Technical BULLETIN

2002 SXV700G, SXV700ERG

Hood & Belly Pan Misalignment & Hood Cracking

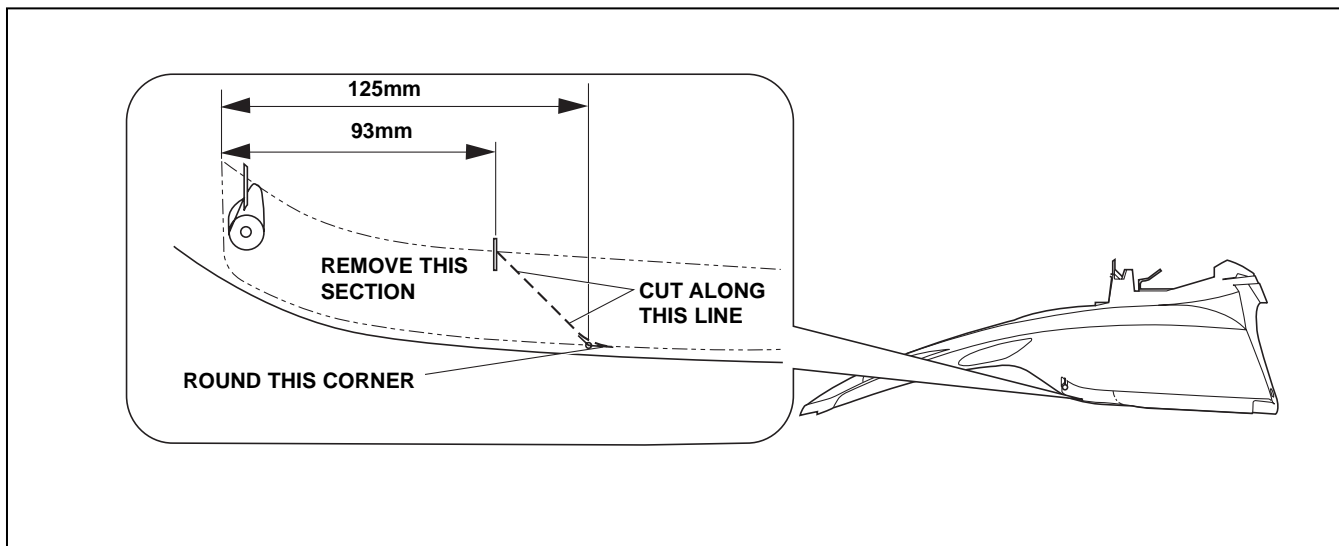
1. **Hood Modification:** Remove a section of the forward inside edges of both right-hand (RH) and left-hand (LH) locating channels as shown in the illustration below:

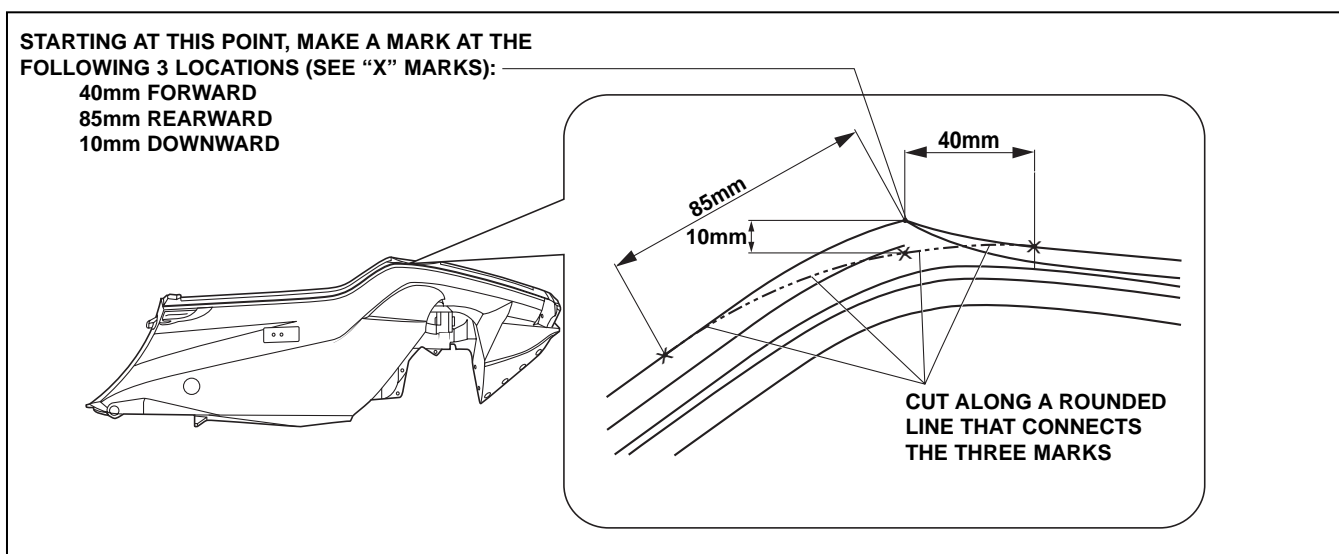
2. **Belly Pan Modification:** Remove a section of both right-hand (RH) and left-hand (LH) sides of the belly pan as shown in the illustration below. Take care not to remove excess material to avoid a gap between the hood and belly pan.
